M E M O R A N D U M

SUBJECT: **SP21-133 Lincoln Professional Park Filing No. 1 Lot 1 Site Plan**

LINCOLN PROFESSIONAL PARK FILING NO. 1 LOT 1
MAVERIK INC. STORE SITE PLAN

COVER SHEET

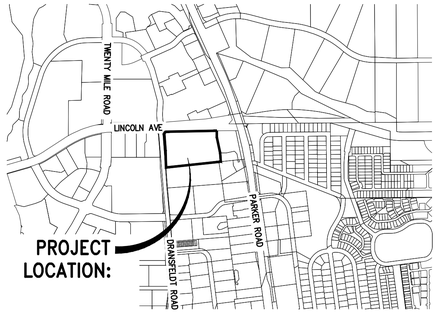
These were separate submittals. Not sure if this was due to upload issues, but they will need to be included in the overall Site Plan.

ACCESSIBLE STALL DETAIL

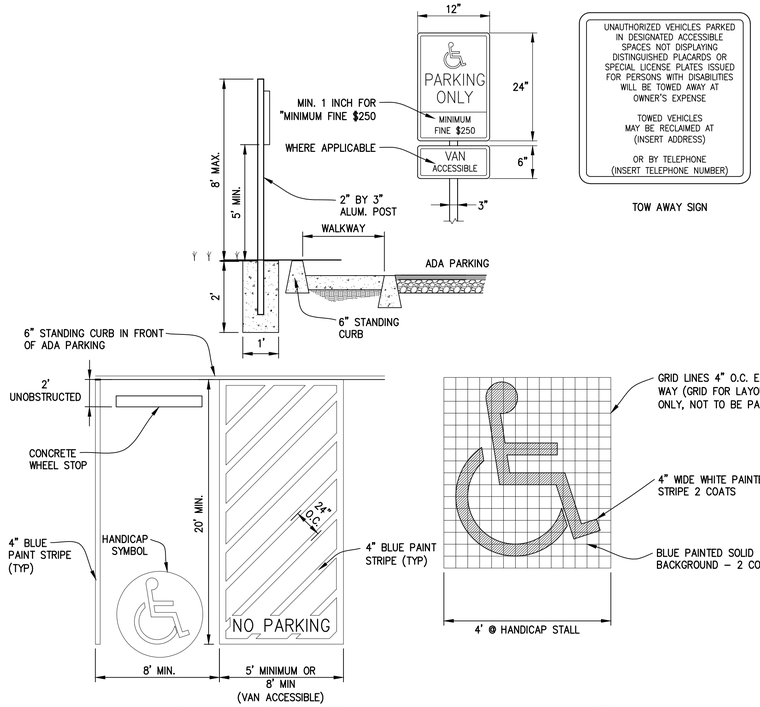
What are these? If these are proposed lights, they will need to be shielded and shown on the photometric plan.

LANDSCAPE PLAN

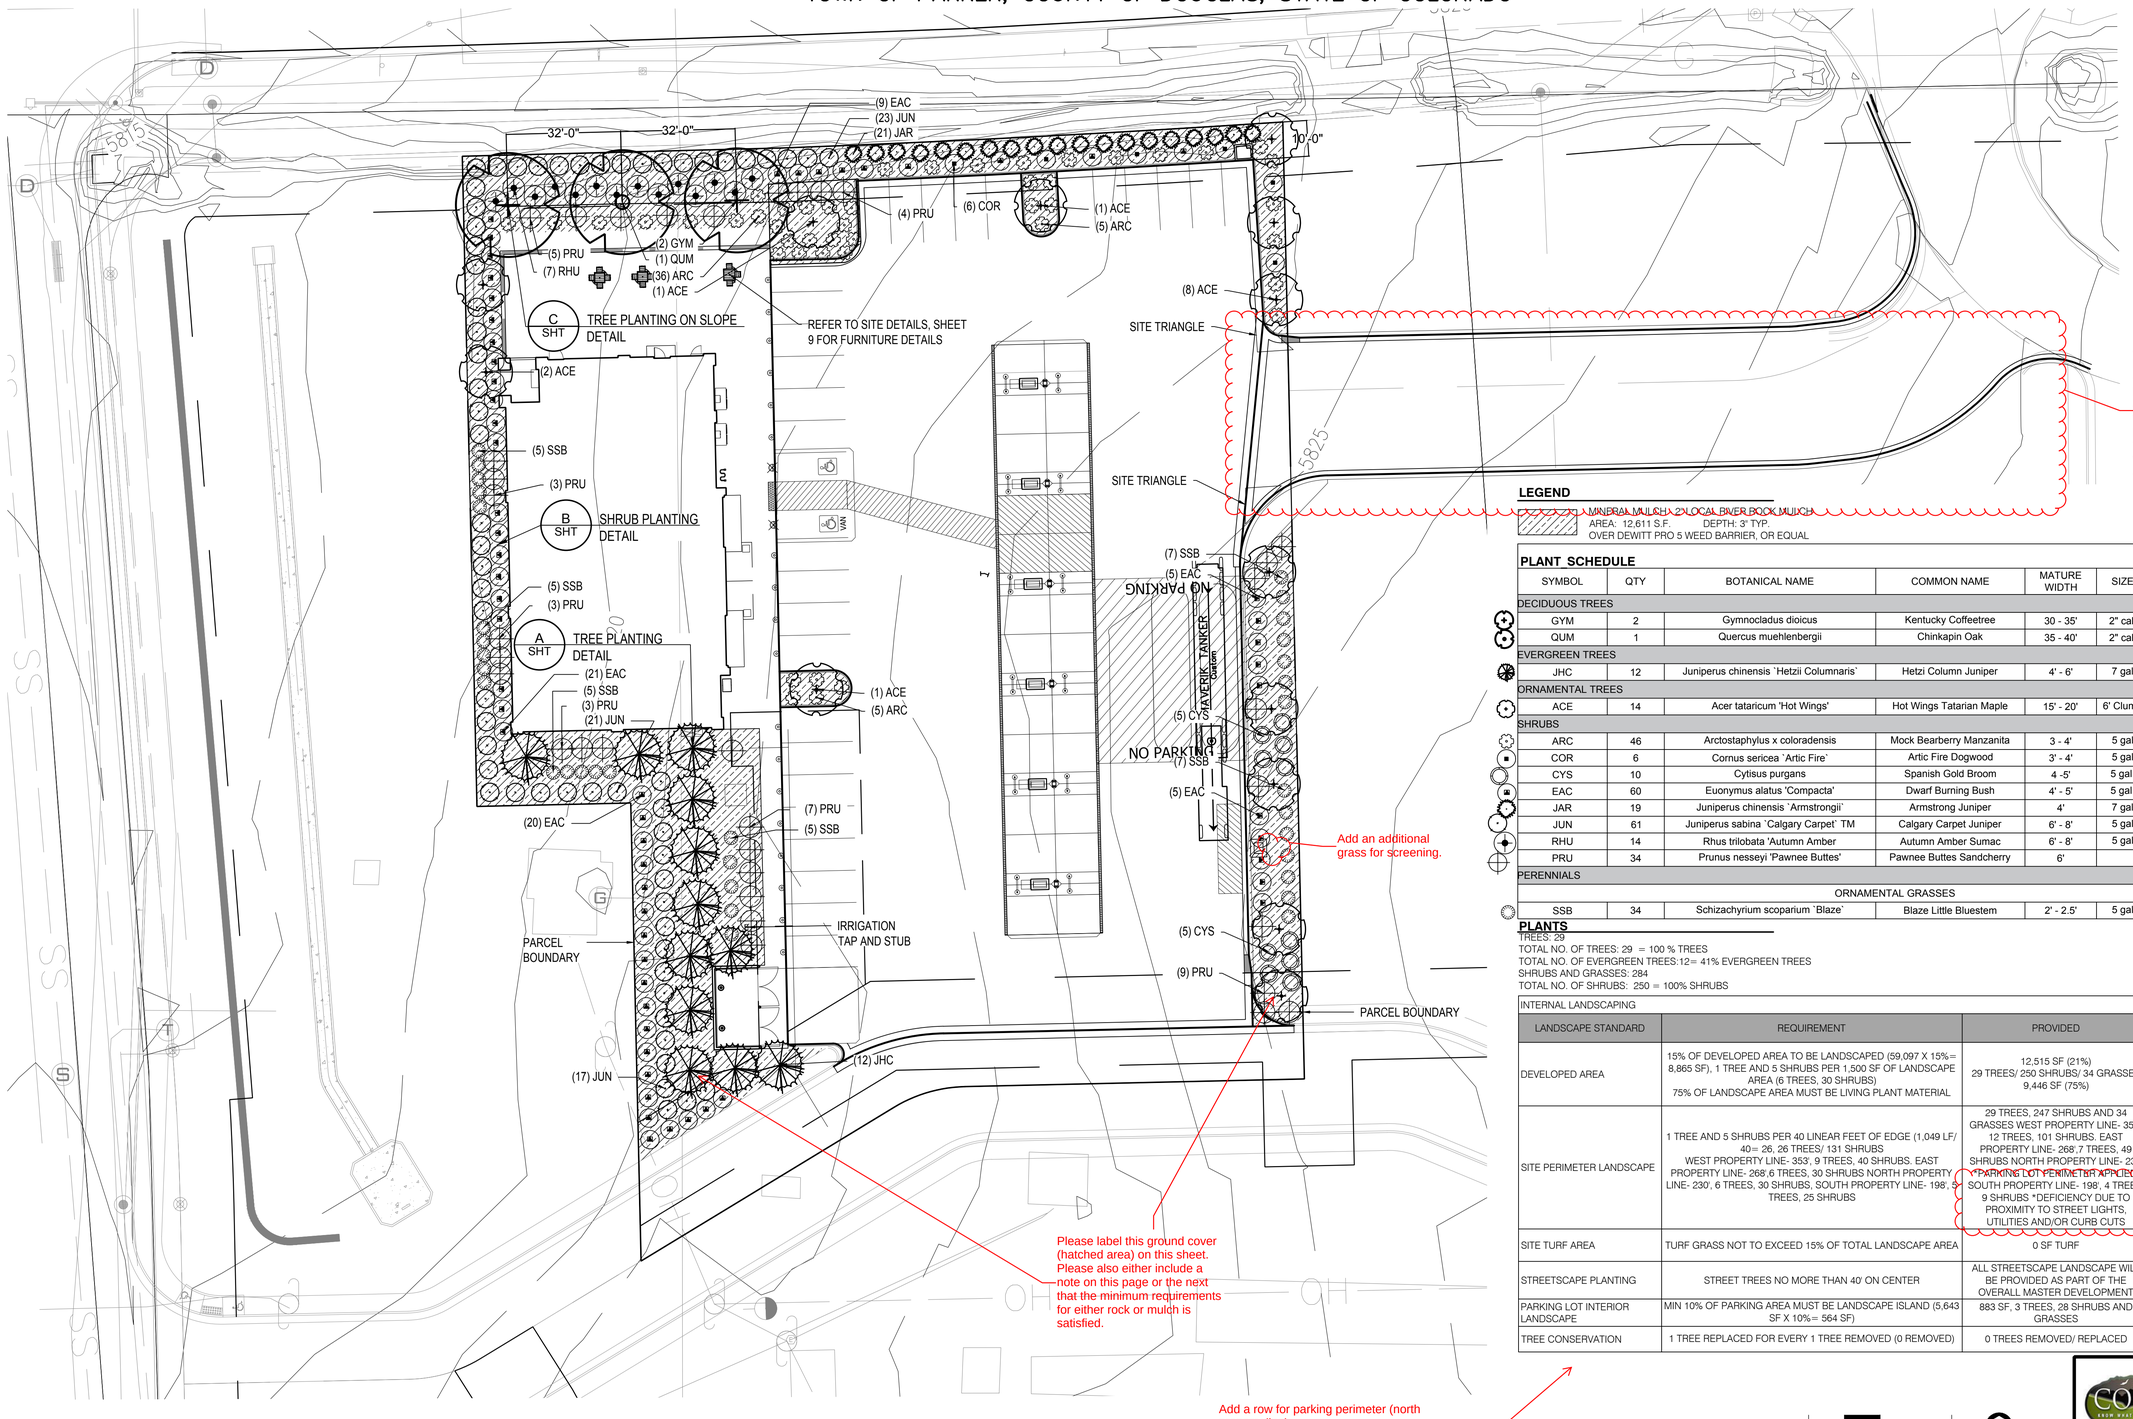
All sidewalks should be shown per previous comments. Streetscape will be required per comments for the MDP. Also, once pedestrians have walked this way to the property, how will the access the convenience store without walking through the parking and drive aisles?

Add an additional grass for screening.

Please label this ground cover (hatched area) on this sheet. Please also either include a note on this page or the next that the minimum requirements for either rock or mulch is satisfied.

Add a row for parking perimeter (north property line).
Required 10'
Provided 10" ## Shrubs ## Trees

1 E-1.2 **SITE PHOTOMETRIC PLAN**
SCALE: 1"=30'-0"

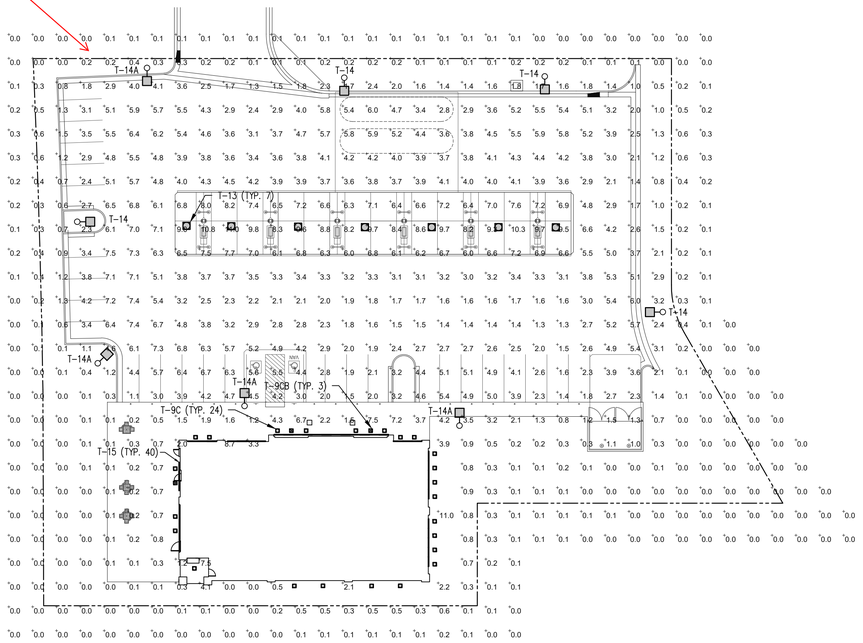
Please enlarge this plan to make sure that it is legible once printed.

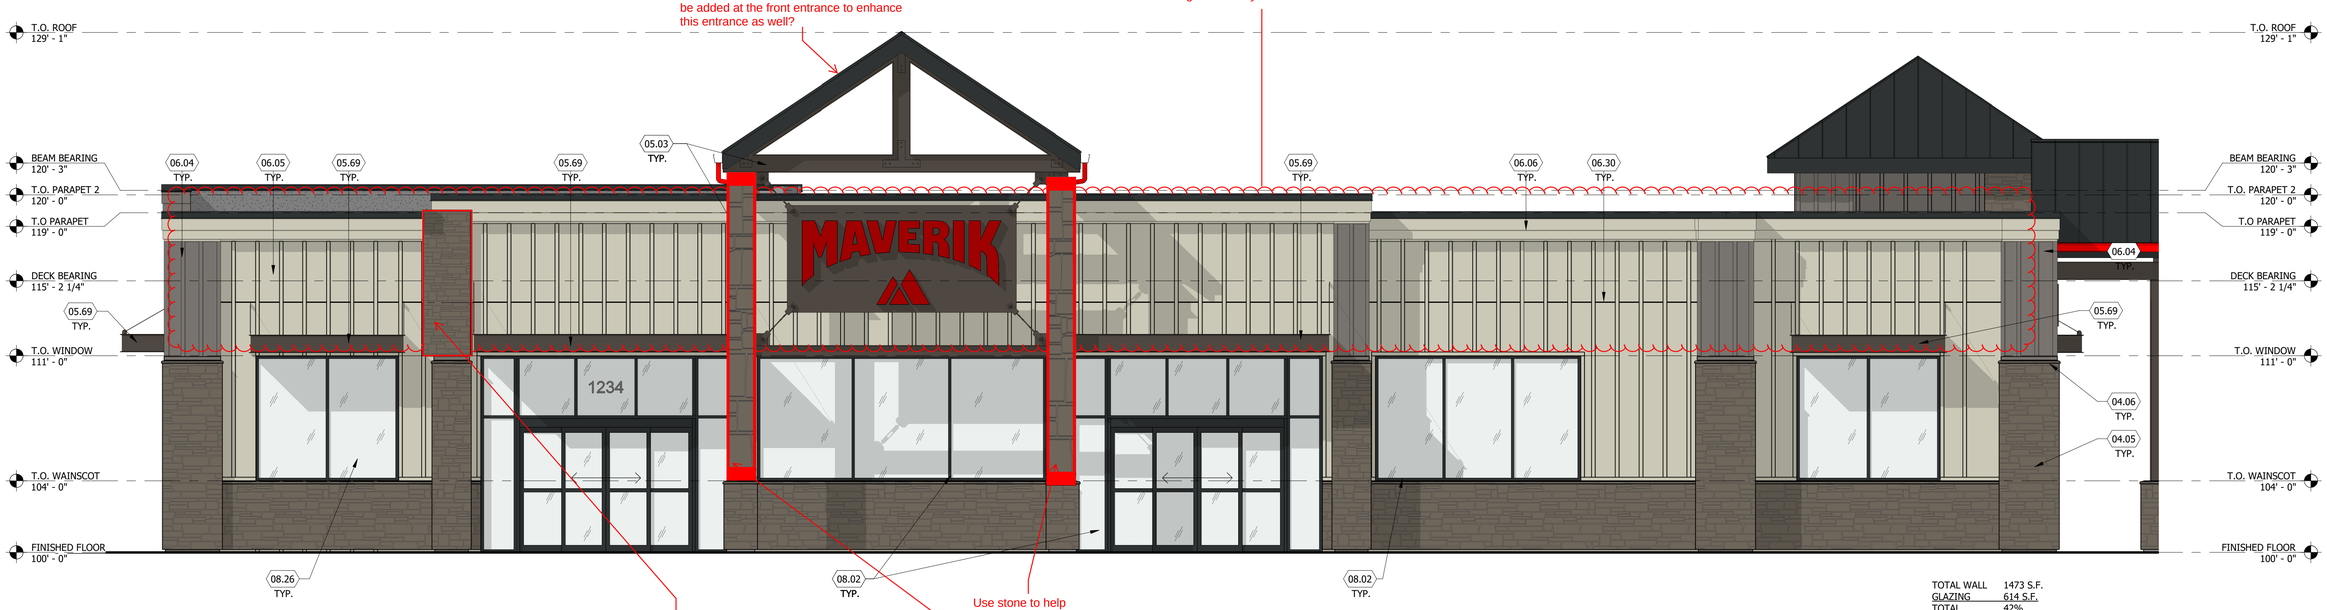
Staff appreciates this additional roof form to meet the corner element. Can this also be added at the front entrance to enhance this entrance as well?

Use paint color to help break up this building horizontally.

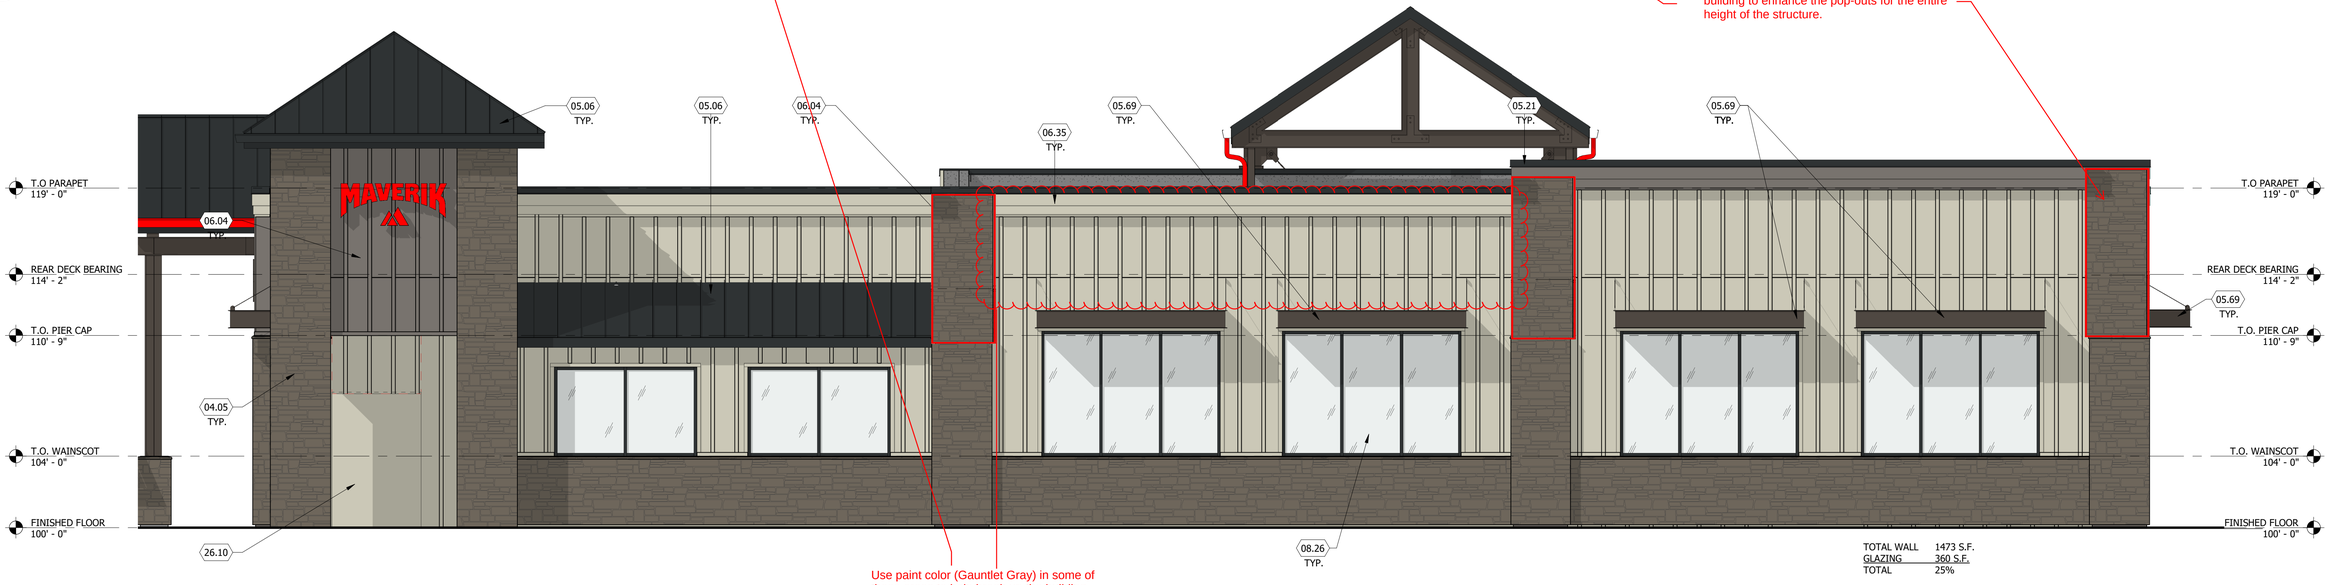
Please include the stone all the way up the building to enhance the pop-outs for the entire height of the structure.

2 FUEL DISPENSING CANOPY - BUILDING SIDE ELEVATION
SCALE: 1/4" = 1'-0"

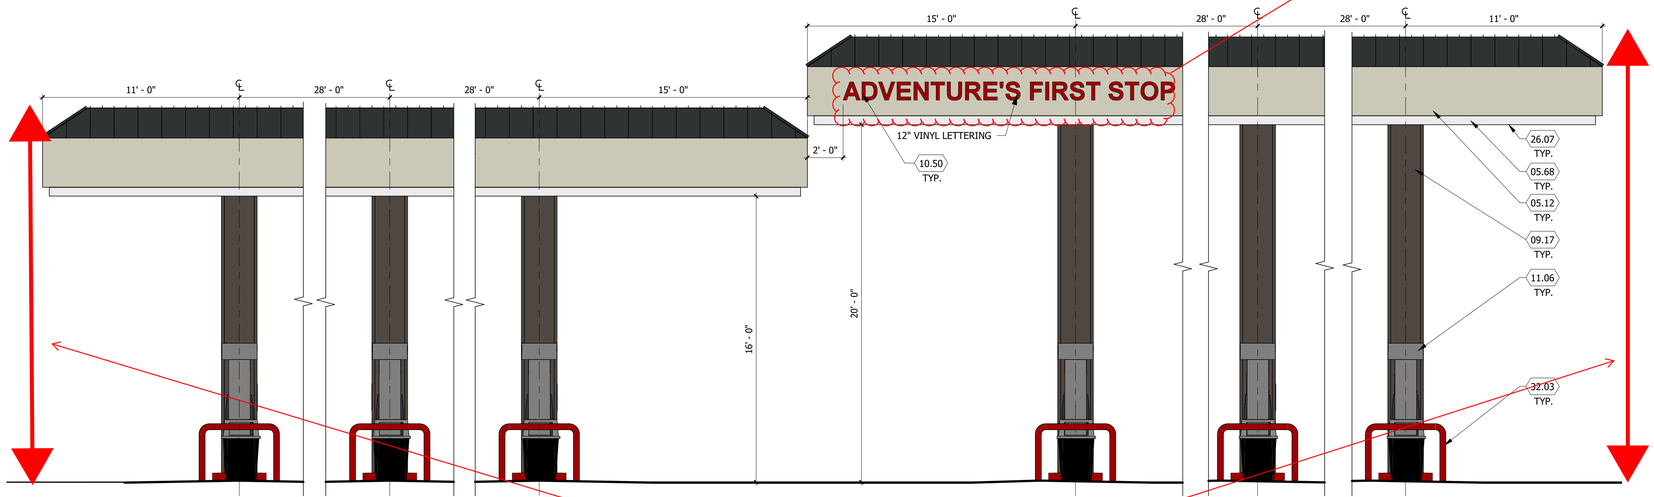
FYI= no signage is approved as part of the Site Plan. Separate Sign Permits will be required that will be reviewed to ensure compliance with the Town's Sign Code.

Please label all materials consistent with the convenience store.

1 FUEL DISPENSING CANOPY - STREET SIDE ELEVATION
SCALE: 1/4" = 1'-0"

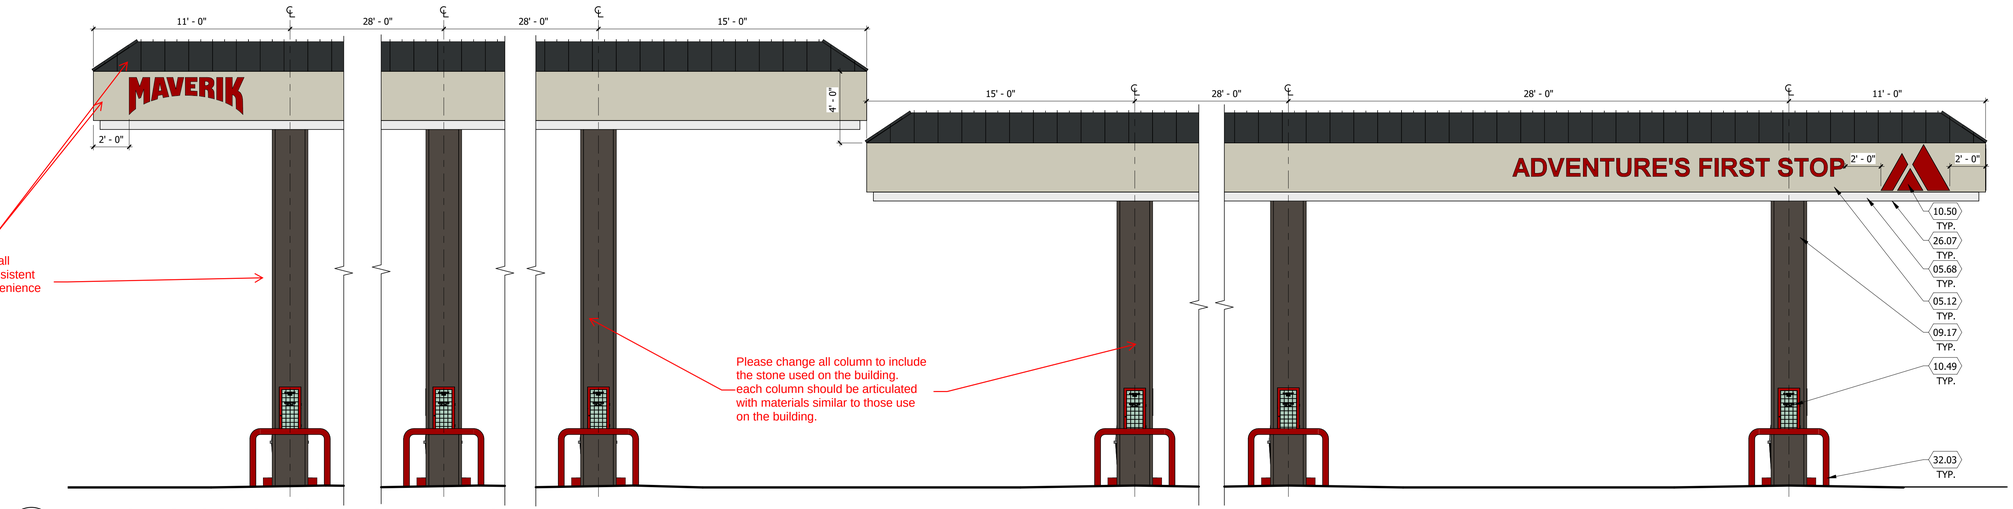
Please change all column to include the stone used on the building. each column should be articulated with materials similar to those use on the building.
